Application No.	Applicant(s)			
	10/629,112	SAKAMOTO ET AL.			
Office Action Summary	Examiner	Art Unit			
	Eric Woods	2628			
The MAILING DATE of this communication appears on the cover sheet with the correspondence address Period for Reply					
A SHORTENED STATUTORY PERIOD FOR REPLY WHICHEVER IS LONGER, FROM THE MAILING DA - Extensions of time may be available under the provisions of 37 CFR 1.13 after SIX (6) MONTHS from the mailing date of this communication. - If NO period for reply is specified above, the maximum statutory period w - Failure to reply within the set or extended period for reply will, by statute, Any reply received by the Office later than three months after the mailing earned patent term adjustment. See 37 CFR 1.704(b).	ATE OF THIS COMMUNICATION 36(a). In no event, however, may a reply be tim will apply and will expire SIX (6) MONTHS from cause the application to become ABANDONE	N. nely filed the mailing date of this communication. D (35 U.S.C. § 133).

DETAILED ACTION

FIG. 3

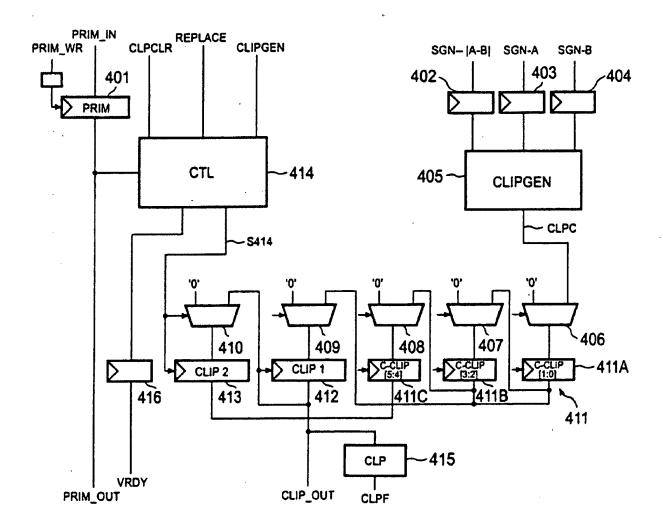
Firstly, it is instructive to refer to applicant's description of an embodiment (Figure 3) in drawing format:

Applicant's system shifts values in the registers as in $A \rightarrow B \rightarrow C$ format (411 \rightarrow 412 \rightarrow 413) as explained above.

Specifically, in Figure 3, the written description filed on 03/21/2005 (corrected) describes the data line between register 411 (page 18, [0111]) as follows: "The current clip registers 411A to 411C, that is, the current clip registers 411, output the 6-bit output to the multiplexer 409..." The drawings do not support this. The data line connecting registers 411A, 411B, and 411C to multiplexer 409 [0111] only show dots (connections) between the outputs of 411A and 411B, but not 411C. Such a bus could only therefore

be 4 bits wide, not the recited 6 bits. Thusly, the connection between that bus and 411C needs to be illustrated.

Corrected drawing sheets in compliance with 37 CFR 1.121(d) are required in reply to the Office action to avoid abandonment of the application.

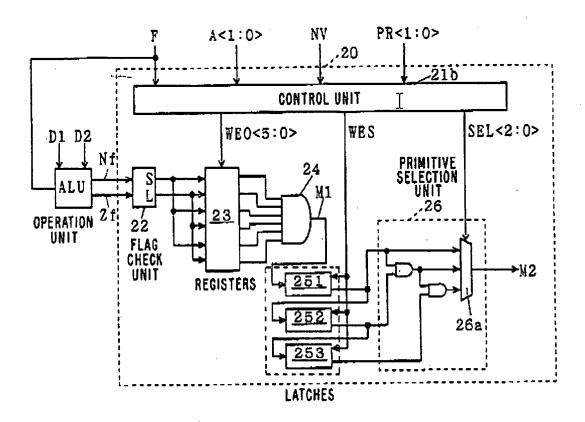
However, applicant takes the position below in the Remarks filed 11/13/2006 with respect to the *Inoue* reference (applicant page numbered 10, first paragraph, quoting from *Inoue*): "Moreover, latches 251-253 'are connected in series and a shift signal WES controls input/output of data. When the shift signal WES is activated, data stored in the latches 251 to 253 are shifted in this order' (8:11-14 and Fig 6). Data stored in the latches may be shifted. However, this does not teach or suggest the claimed 'clip registers cascade connected ...' as recited in claim 1."

This position is clearly erroneous, as shifting data through serially connected latches is the same thing as shifting data through cascade-connected registers, since both elements are doing nothing but holding the results of calculations, and they are both memories. Applicant does not contest that.

F I G. 6

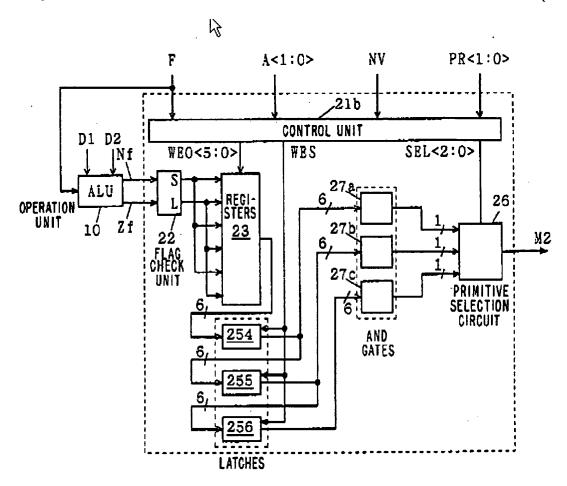
Applicant has clearly conceded that *Inoue* has latches 251-253 that are connected in series (Figure 6 below).

Inoue describes these latches as follows: "In the third preferred embodiment, latches 251 to 253 and a primitive selection unit 26 are additionally provided to the clip-code generation/judgment unit 20 of the first preferred embodiment... The latches 251 to 253 are connected in series and a shift signal WES controls input/output of data. When the shift signal WES is activated, data stored in the latches 251 to 253 are shifted in this order... In other words, the judgment signals M1 on the respective vertices constituting the primitive are **sequentially** stored in the latches 251 to 253..." (8:1-60). That is to say, the data is transferred from the registers to the latches. However, to avoid a

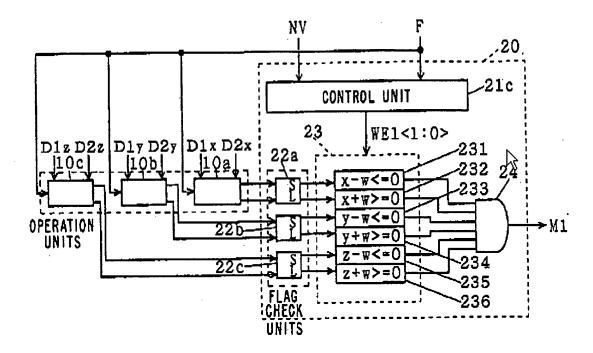
discussion on equivalency, for purely purposes of clarification, examiner now provides *Inoue* Figure 8:

Furthermore, when compared to Figure 8, it can be **clearly** seen that the information in registers 23 are serially transferred through latches 254-256, which are known to be 6-bits wide as described above.

Therefore, it can be seen that applicant's assertion that the method of operation of *Inoue* was different than that in the instant specification was mistaken. Both systems utilize serially connected registers containing the same data (that is, especially when *Inoue* Figure 8 is considered).

Wherein Registers 23 are composed as follows, as in Figure 4:

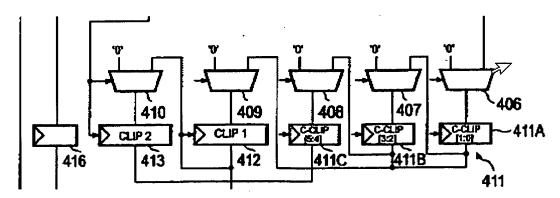
That is to say, as the final result of the above, Inoue's Registers 23 contain the same 6-bit information as the "current clip register" of applicant, that is, they both contain the same results from the same logical operations on the same variables.
